ADDENDUM NO. 3

TO: ALL BIDDERS
FROM: JKF ARCHITECTURE
RE: Edgecombe Community College
Barnes Student Lounge Renovation
SCO ID NO. 23-27150-01A
JKF Project No. 2024-04

PROJECT No.
2024081
DATE
11-11-2024
SCALE
AS NOTED
DRAWN BY
MBM
CHECKED BY
MSR
SHEET No.
SK-01

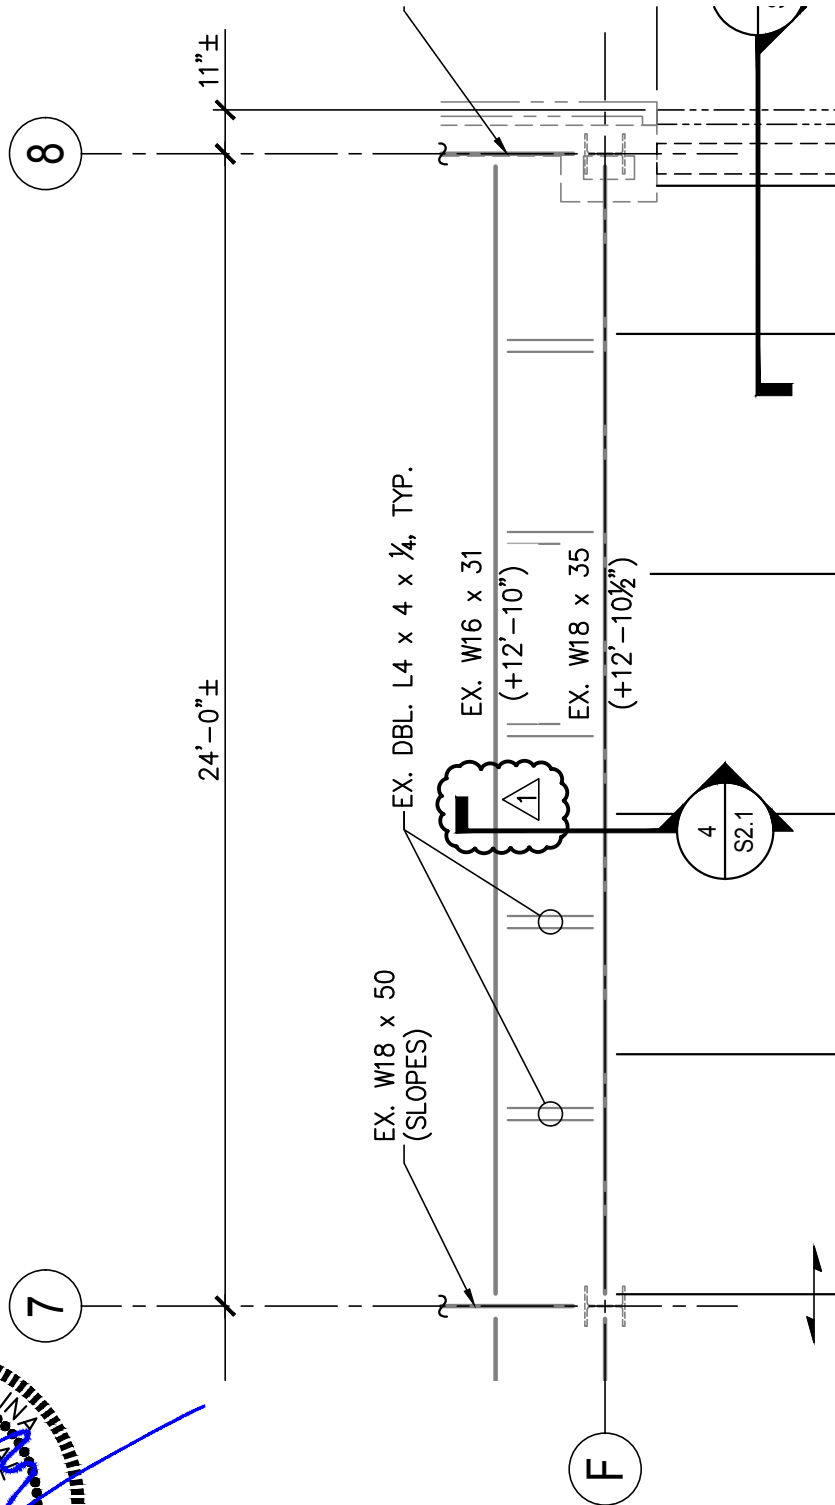
1. See attached Drawing SK-1, dated 11-11-2024. Clarifies demolition of existing steel relaed to existing pre-cast panels to be demolished.
2. See attached Drawing SK-2, dated 11-11-2024. Clarifies demolition of existing steel relaed to existing pre-cast panels to be demolished.

SHEET No.
SK-02

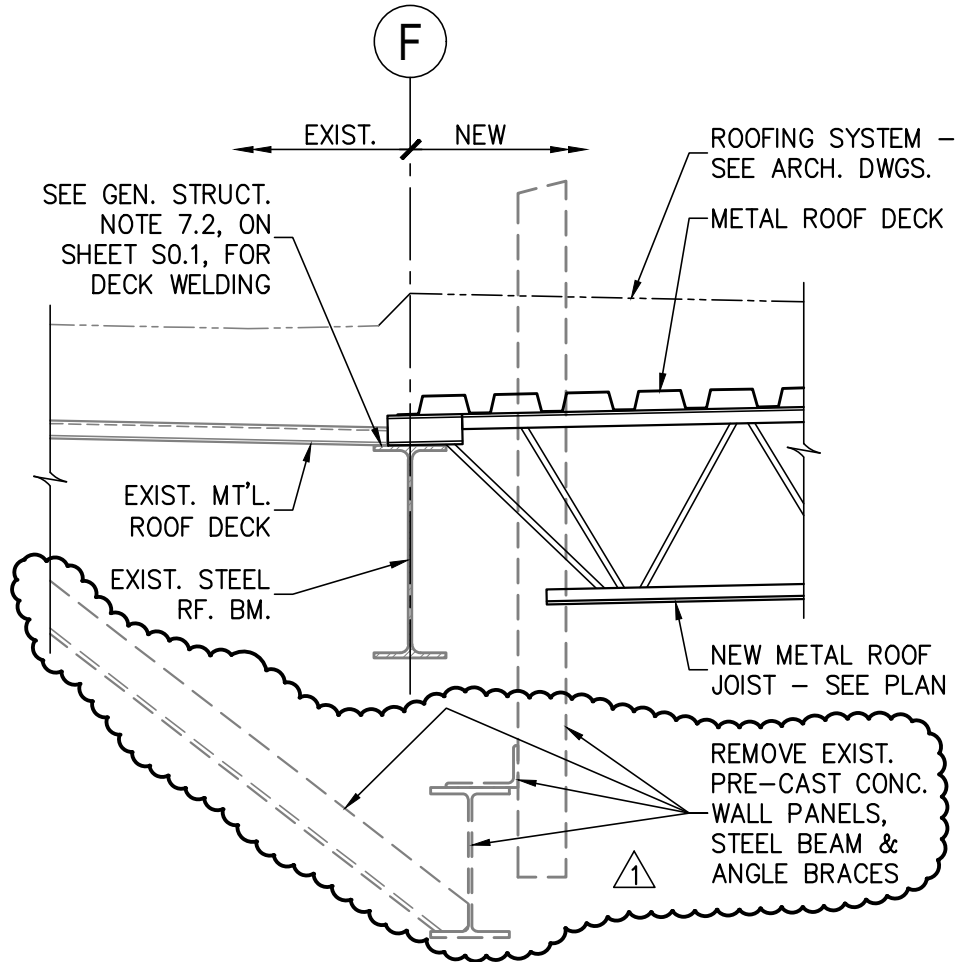
1	4/S2.1, REMOVE EXIST. ITEMS	11-11-2024
NO	REVISION	DATE
